B I D A D D E N D U M 0 2

ARDEN HILL - MAIN BUILDING ADDITIONS AND ALTERATIONS
ORANGE-ULSTER BOCES

BID ADDENDUM #2

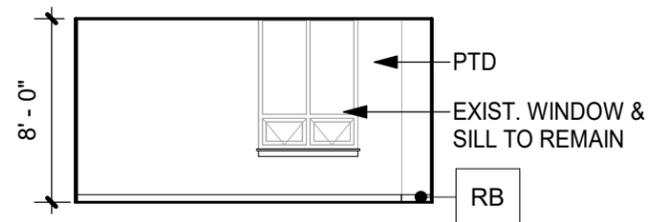
- 7.55 **RFI Question** – Could you please confirm the type of roofing system planned for this project? Additionally, specify the gauge and type of metal to be provided.

RFI Response – The roofing system for the new addition shall be Modified Bitumen per 075226 MODIFIED BITUMEN ROOFING and as noted on the Drawings throughout the A800 series.

See section 076200 SHEET METAL FLASHINGS AND SPECIALTIES for information on roof related metal products. Aluminum fascia shall be .050" per the specifications.

ASK-1

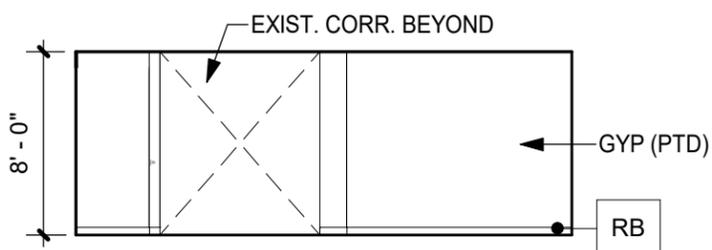
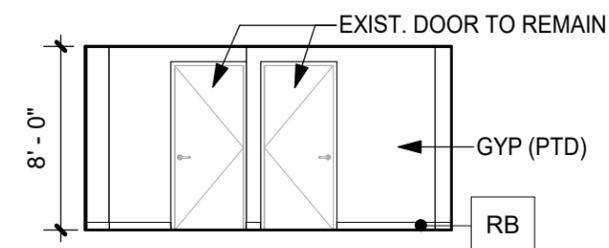
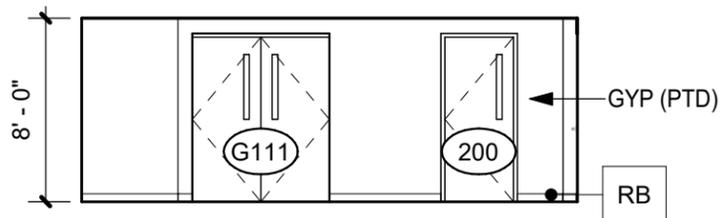
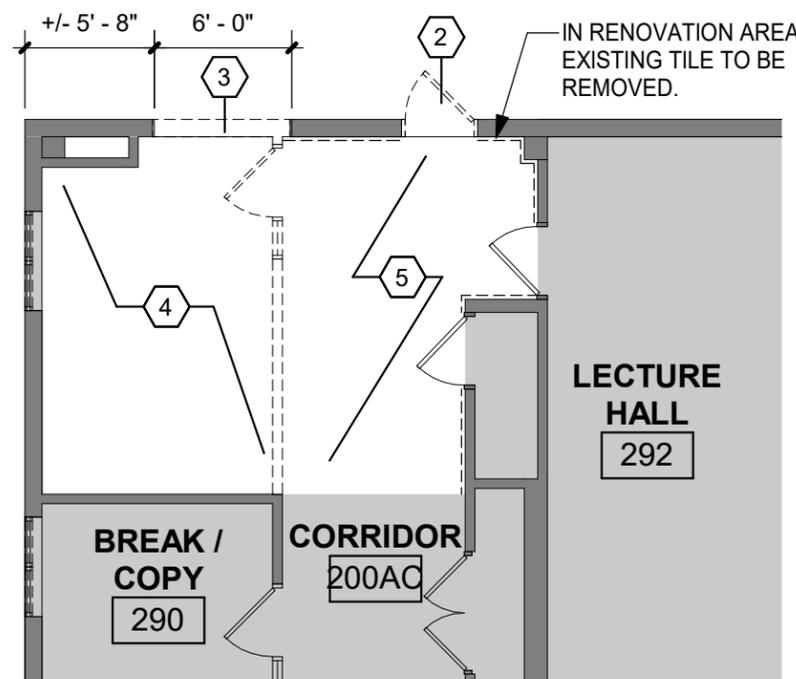
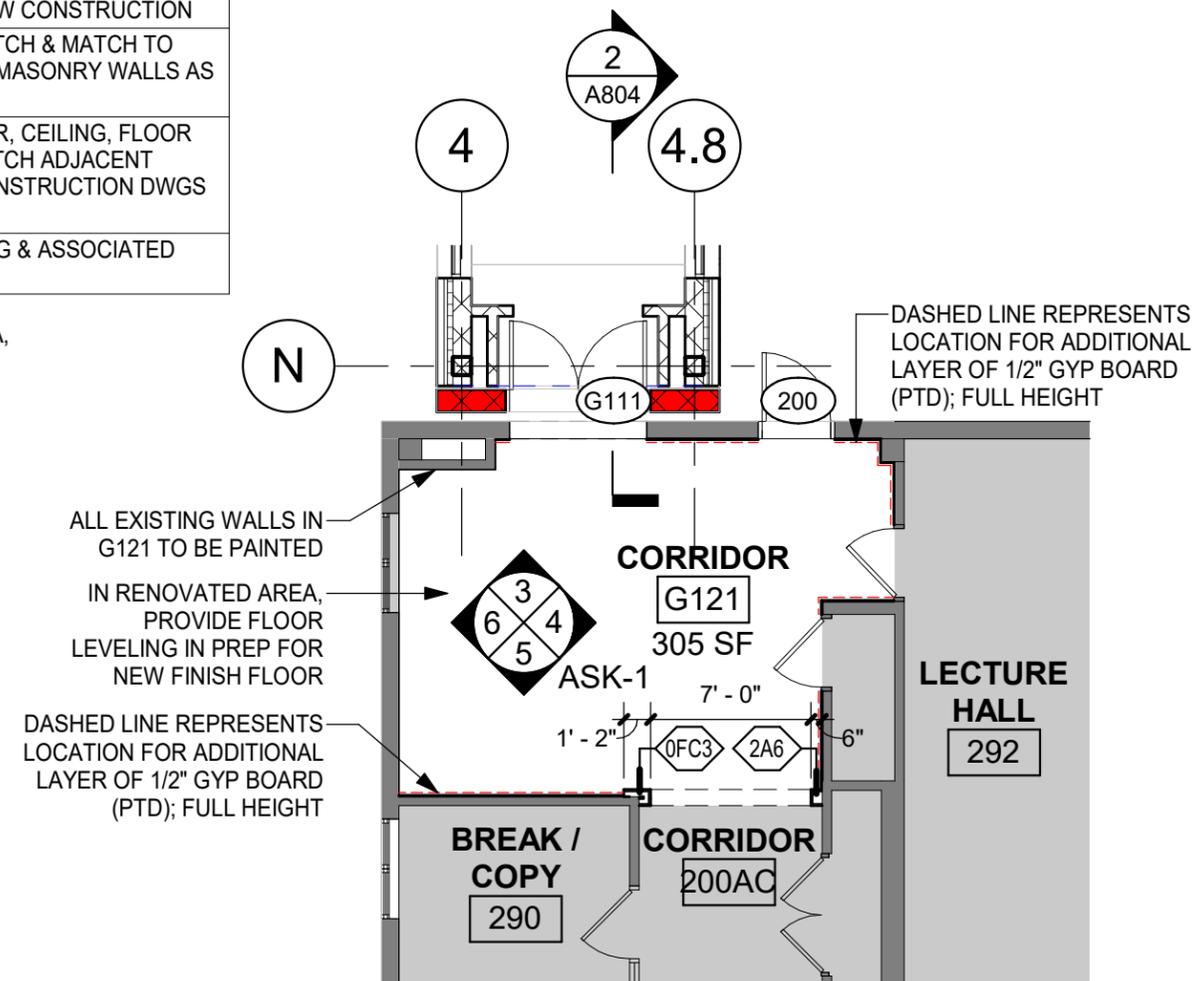
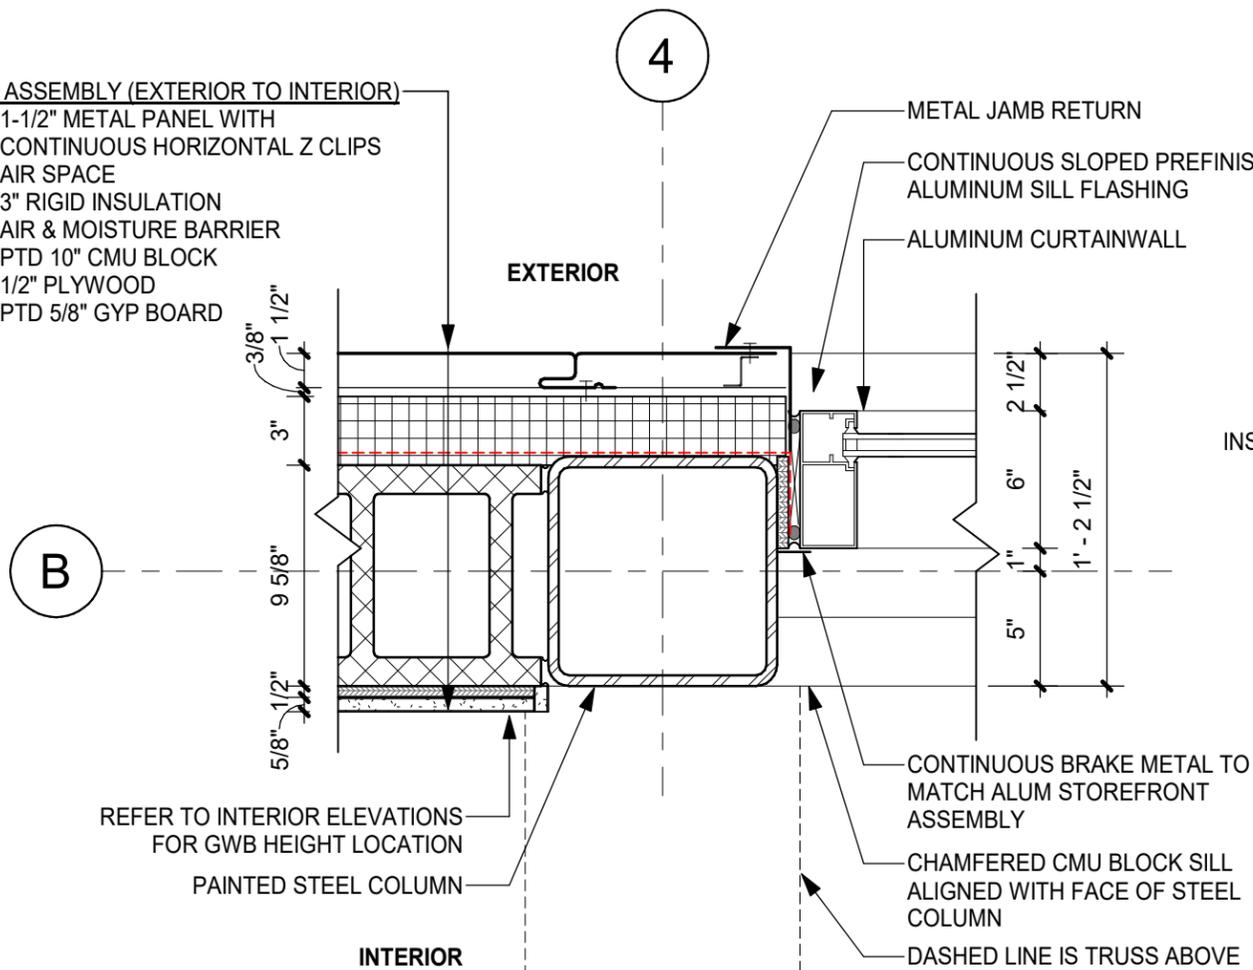
- 7.1 See attached ASK-1 With additional information on the renovations of existing building Corridor G121 in the area of the connecting corridor to the new addition.

- 7.15 **RFI Question** – Spec 011000.08.e.dd calls for concrete (ardex) floor leveling, but does not identify any locations, quantities, nor is there a specific spec for it. Please advise.
RFI Response – Contractor shall provide floor leveling (Ardex K-15 or similar) at area of existing building where new addition connects to existing building. Contractor shall assume maximum thickness of 1/4" for leveling material. See attached ASK-1.

DEMOLITION KEYNOTES	
2	REMOVE EXIST DOOR, JAMB AND ALL ASSOCIATED HARDWARE, EXIST OPENING TO REMAIN, PREP FOR NEW DOOR INSTALLATION - COORD. W/ NEW CONSTRUCTION
3	CREATE NEW OPENING IN EXIST WALL & SAW CUT AS REQ. PATCH & MATCH TO EXIST ADJACENT SURFACES. PROVIDE NEW LINTELS IN EXIST MASONRY WALLS AS REQ - COORD WITH STRUCTURAL & NEW CONSTRUCTION
4	FULL ROOM DEMO - REMOVE INTERIOR WALL PARTITION, DOOR, CEILING, FLOOR FINISHES, BUILT-INS, CASEWORK, AND LIGHTING. PATCH & MATCH ADJACENT SURFACES. PREP FOR NEW WORK IN THIS AREA. SEE NEW CONSTRUCTION DWGS FOR MORE INFORMATION.
5	REMOVE & DISPOSE FLOORING, WALL TILE, CEILINGS, LIGHTING & ASSOCIATED HARDWARE. PREP FOR NEW WORK.

ASK-2

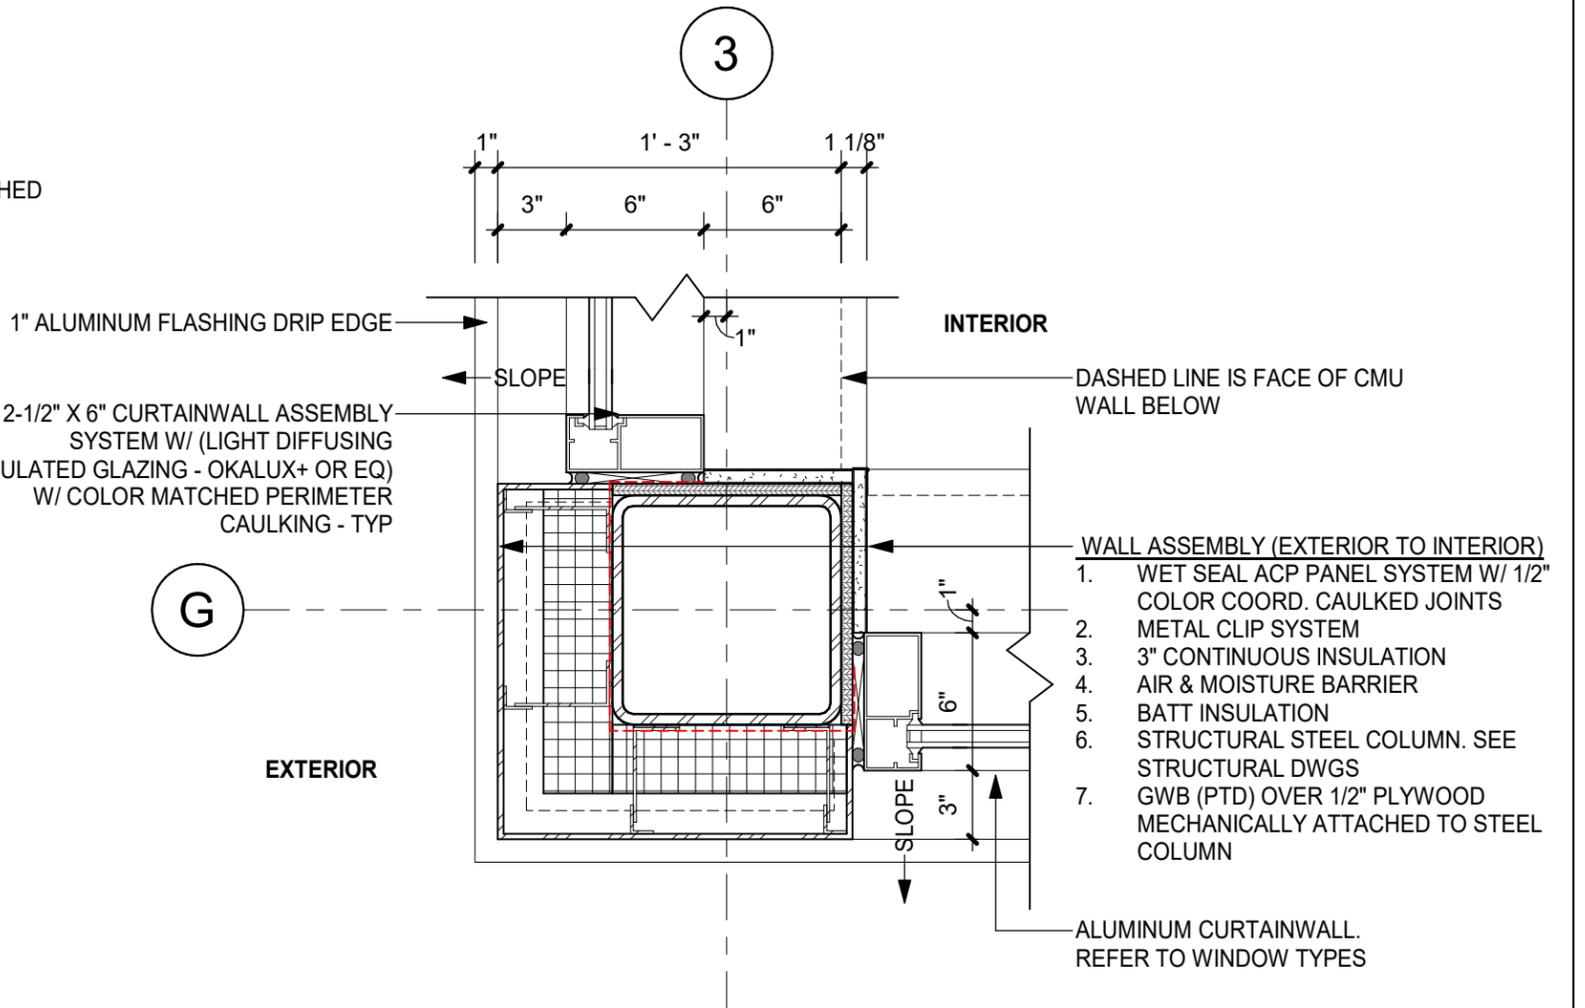
- 7.2 See ASK-2 With revised plan details for 6" curtain wall at gym upper windows.
- 7.3 All plywood used at exterior wall and exterior roof/overhang construction shall be fire-retardant treated. See Specification 061050 Part 2.3 for product information and requirements.

1 PLAN DETAIL - REAR GYM CLERESTORY
1 1/2" = 1'-0" SHEET A830 AFFECTED

2 PLAN DETAIL - CORNER COLUMN COVER @ CLERESTORY
1 1/2" = 1'-0" SHEET A831 AFFECTED
